EXECUTIVE SUMMARY OF KEY COMMENTS

We respectfully submit the following public comments regarding application GRDE18-0114 by Ravensdale LLC to expand their mine trench filling project on Ravensdale Ridge. We submit these comments as private citizens. As background, we have lived adjacent to this property for 45 years – long before Ravensdale LLC’s ownership. We assisted the prior owners, Plum Creek Timberlands, as volunteers in helping manage recreational use following their clearcutting of the property in the mid- to late-1970’s. We were enlisted as Volunteer Land Stewards, responsible for monitoring this property, by Cascade Land Conservancy (now Forterra), in 2007 – just after Ravensdale LLC’s principals, Kurt Erickson and Fred Wagner, purchased the property from Plum Creek. Forterra owns three separate Conservation Easements that deal with forestry practices, development, and recreational use of this property. We have been monitoring harvest, trench filling, and other activity on this property for the past 11 years. In this role, we have worked closely with WA DNR and with KC DDES/DPER. We have also spent five years researching the 119-year history of Ravensdale, much of which

North-face component of proposed C-Trench. Note town of Ravensdale in background. Oct 7, 2018.

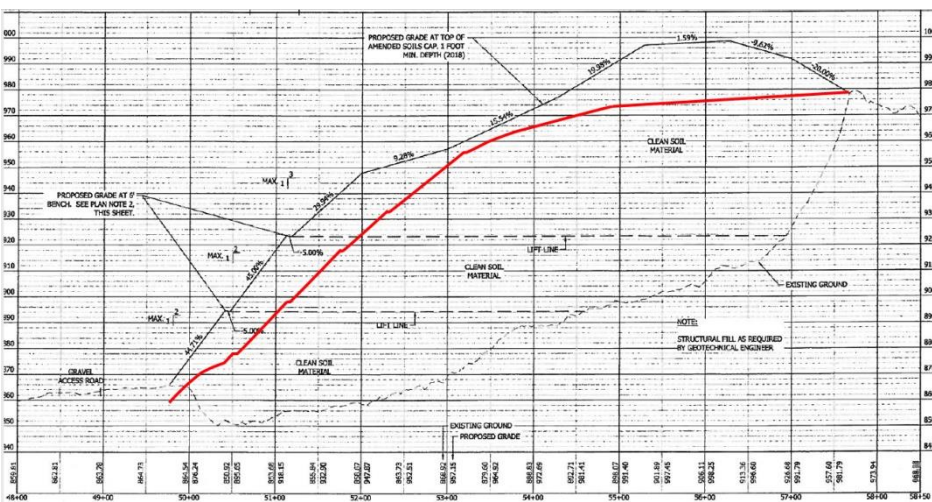
We recommend not approving the small, north-facing portion of this new trench. Unlike any of the other 10 trenches in this proposal, this new addition to C is on the very steep, north face of Ravensdale Ridge; and is very visible from the town of Ravensdale, from Ravensdale Park, and from 268th Ave SE and the Landsburg Road coming into Ravensdale. ALL of the filling to date, and most all of this proposed project expansion application, is largely hidden from the public behind locked gates, with numerous No Trespassing signs posted throughout the property. The high public visibility of this small portion of C may very well lead to a significant public backlash to this overall project.

But an even bigger concern is that past history on this project would indicate there is no reliable way to contain the fill on this kind of slope to the permitted footprint, and keep the fill from continuing to flow on down the very steep face of the Ridge. While such an event may not cause any serious environmental damage, the public reaction to such a visible failure could result in significant negative repercussions.

For these reasons, we strongly suggest NOT approving filling of this new, small, north-facing portion of C-Trench.
